Questions: 6th November 2017

Answers: 18th November 2017

CMS MUON TDR Review (RPC part)

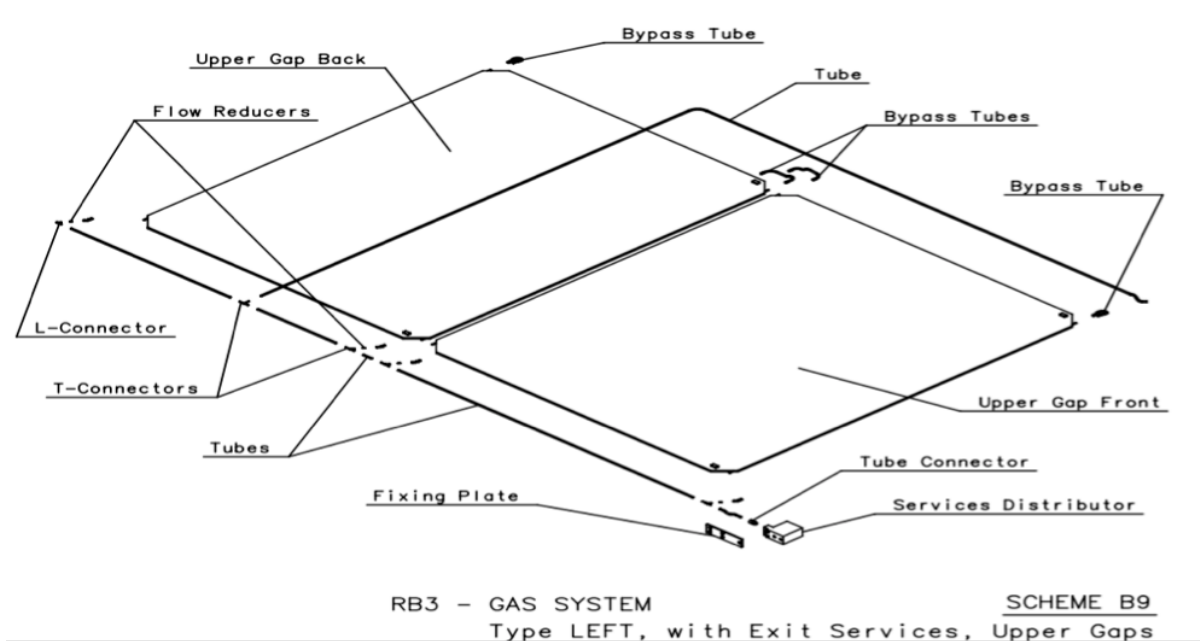
Q47. iRPC gas-tightness. It would be desirable to see an explicit list of components (e.g. in the gas supply manifold) which are the main source of leaks in the existing RPCs, and an explanation for how these components are being avoided/substituted in the iRPCs. In addition, will there be a more extensive leak-checking campaign before & during installation?

As explained in the answer to Q46, the gas leak in CMS RPC is happening in the RPC Barrel chambers. They were demanding additional components (not used in the endcap chambers) in order to join 2 adjacent gaps in the same chamber layer (see Upper Gap Back and Front in fig1). This action was demanded because of the significantly larger dimension of barrel chambers wrt endcap ones.

Here in the following some technical drawings of the CMS RPC barrel and endcap chambers, showing the major differences in the gas distribution inside the barrel chamber mechanical structure. The weak element is the so called T-Connector, visible in the Barrel chambers and completely absent in the endcap chambers.

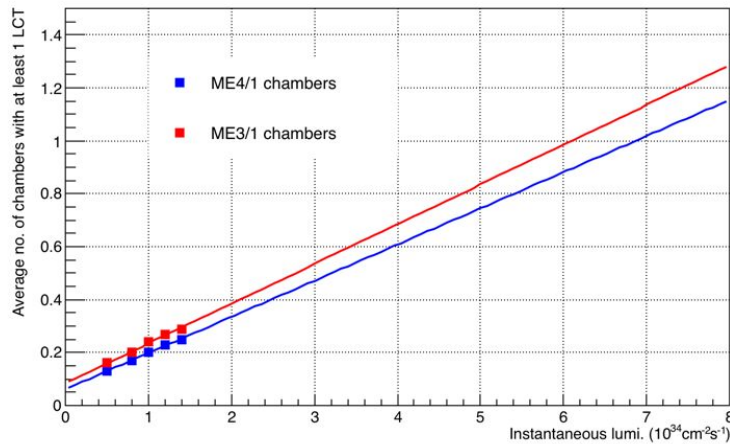
Is it used for L1 trigger? What would be the impact for trigger performance?

Using a data-driven method (minimum bias 2016) we estimate that at $L=5 \times 10^{34} \text{cm}^{-2} \text{s}^{-1}$ the chance to find an LCT in any given ME3/1 chamber will be about $0.8/36 = 2.2\%$ (ME4/1 chambers are similar). When EMTF tries to find a L1 muon, it checks and uses LCTs from 3 consecutive BXs. So overall, if there is a muon going through MEx/1 chambers, the chance to have an extra track in ME3/1 or ME4/1 chamber with the muon is about $(0.8/36) \times 3 \times 2 = 13\%$ [2].

TO be estimated the impact on solving the ambiguity using 2 D readout (with 2 cm resolution along y and with 10 cm resolution).
